## #2020-04 McDonald's SUP Amendment & Variation Project Review for Planning and Zoning Commission

<b><u>Meeting Date:</u></b>	February 19, 2020
<b><u>Requests:</u></b>	1) Special Use Permit Amendment to allow changes to the approved elevations and site plan, and 2) Sign variation to allow 97 square feet of wall signage, a variation of 22 feet.
<b><u>Location:</u></b>	7615 U.S. Route 14
<b><u>Acreage:</u></b>	Approximately 1.30 acres
<b><u>Zoning:</u></b>	W – Watershed Planned Unit Development
<b><u>Surrounding Properties:</u></b>	North: County B-1 – Neighborhood Business South: B-2 PUD – General Commercial Planned Unit Development East: W – Watershed Planned Unit Development West: County B-1 – Neighborhood Business
<b><u>Staff Contact:</u></b>	Kathryn Cowlin (815.356.3615)

Project Title: McDonalds Remodel - Crystal Lake

**SHEET TITLE**  
 ARCHITECTURAL SITE PLAN & DETAILS

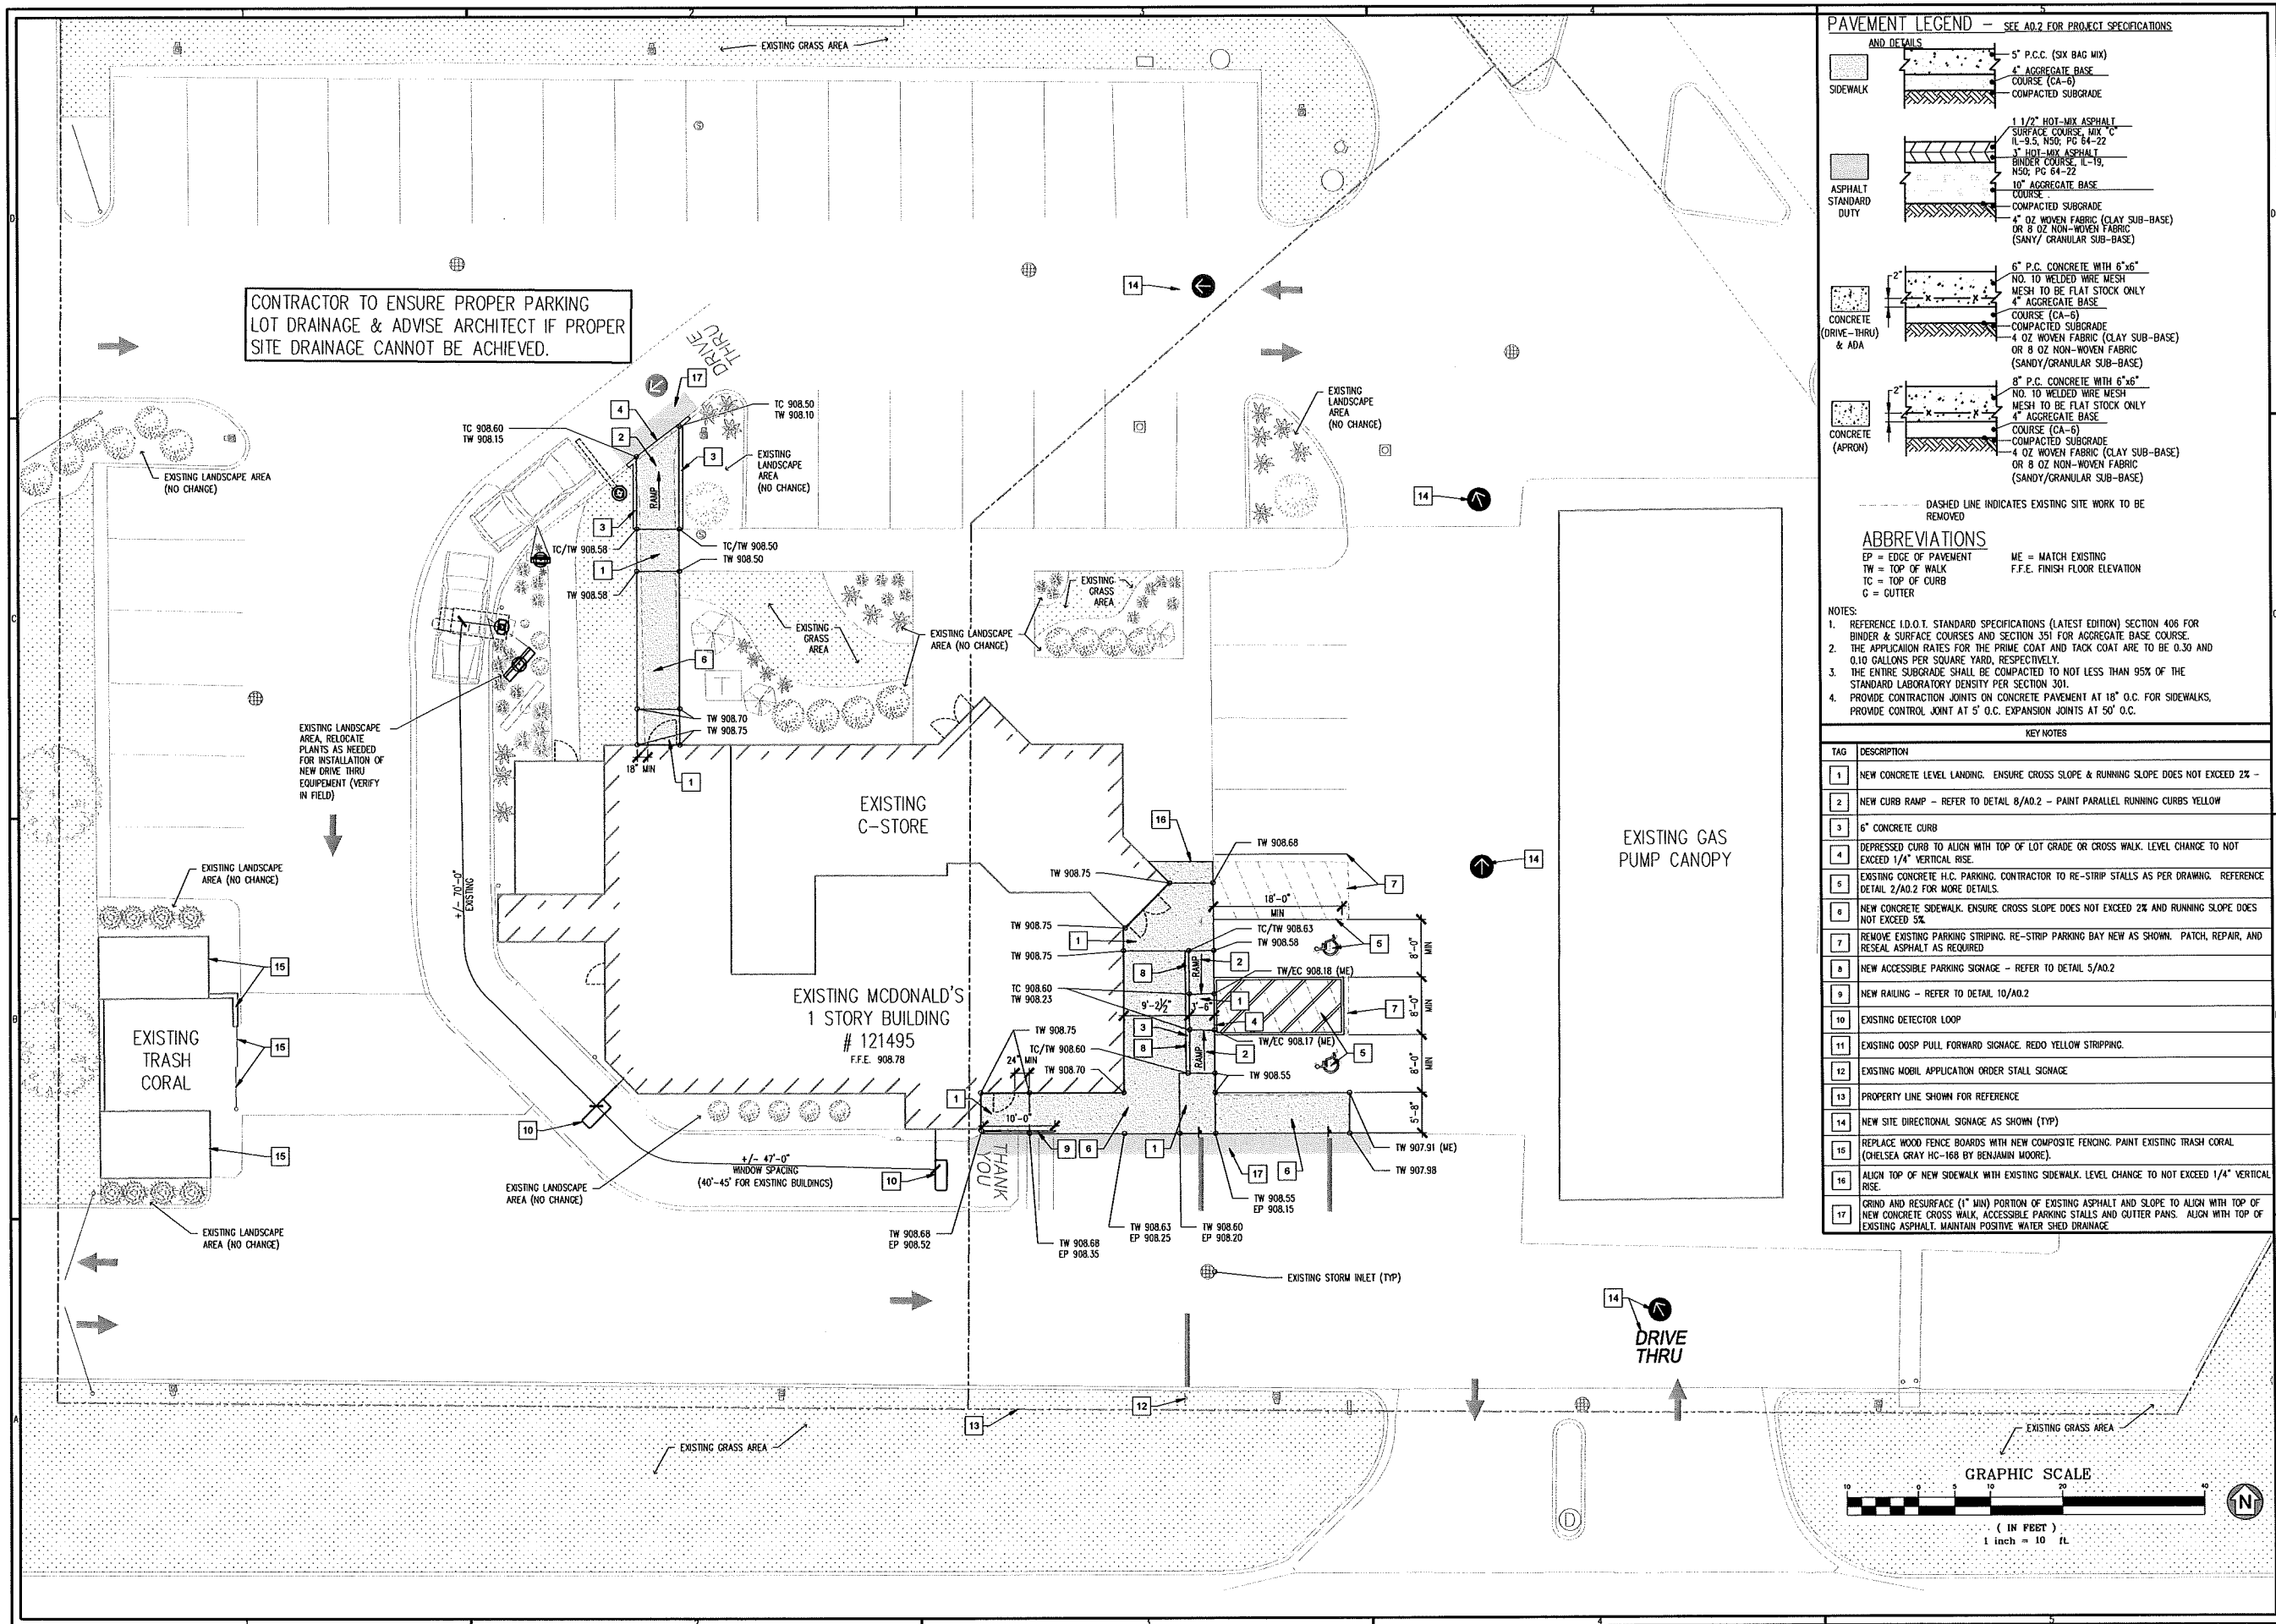
- Minor alterations to the sidewalk and front entrance area are proposed to address ADA requirements.

4. Expand the garbage enclosure area or indicate how all the waste and recycling receptacles will be fully enclosed. The garbage enclosure must be painted the same color as the building.

SHEET TITLE  
**EXTERIOR ELEVATIONS**

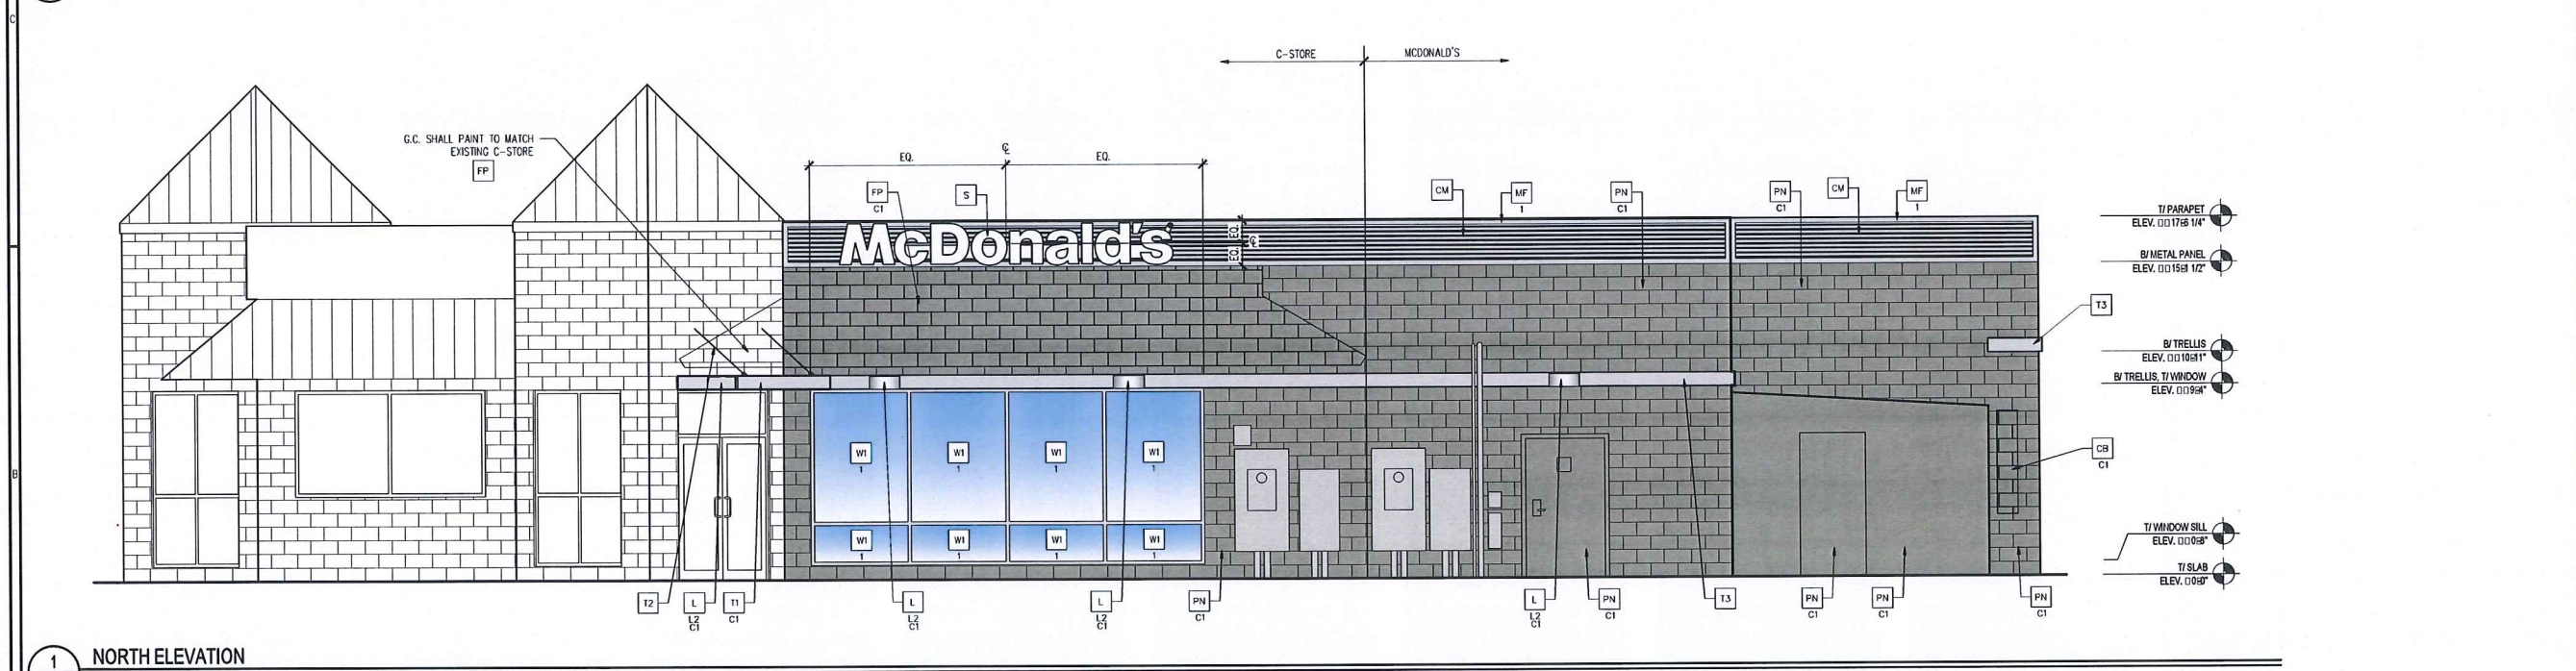
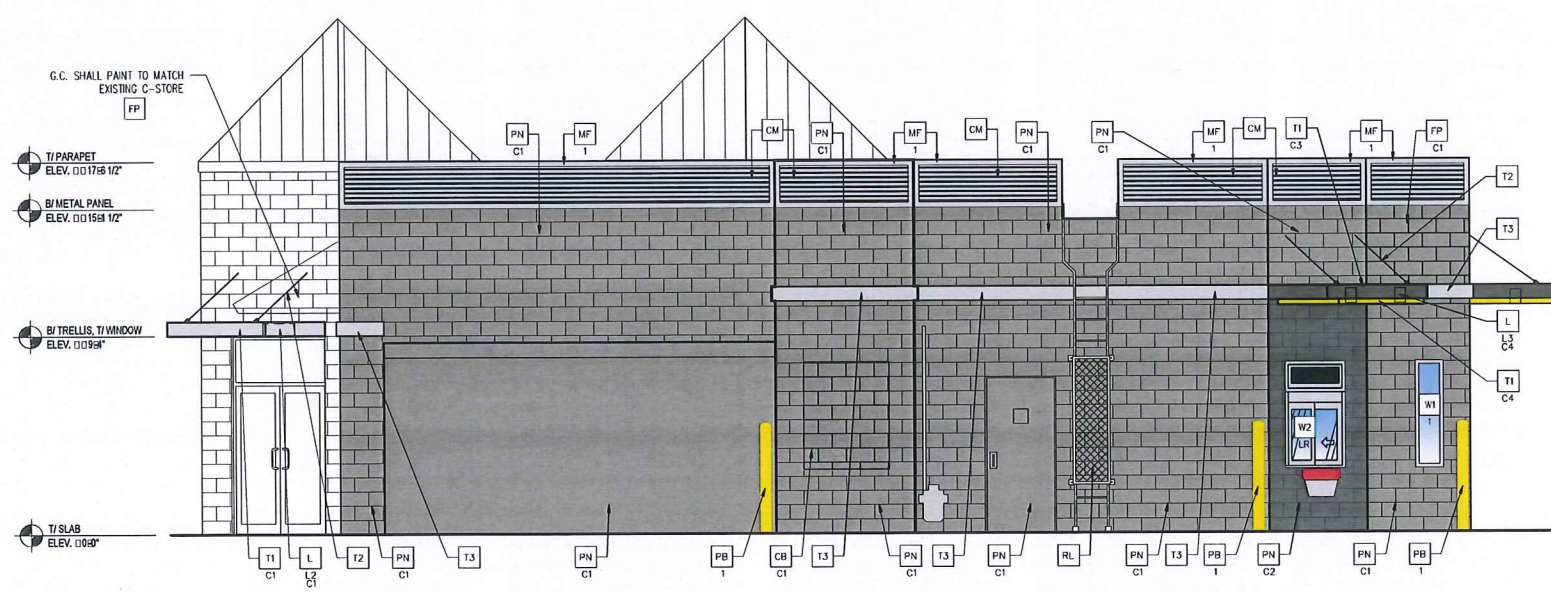
- The existing building is constructed of concrete block and the branded McDonald's red roof with illuminated bands.
- The proposed changes will be compatible with the existing BP side of the building.
- The tacked on mansard roof would be removed. Metal awnings and corrugated metal will be utilized to accent the façade in gray tones.
- The proposed façade is accented with fiber cement tile and the color scheme is gray.
- In order to meet the UDO design standards for a commercial building, staff is recommending adding the fiber cement panel to the drive-through window areas.

- D. Sign Plan (Everbrite, dated 03/01/2017, received 01/16/2020)
2. Provide Iron Mountain colored fiber cement panels on the columns where the drive-through windows are located instead of the paint.
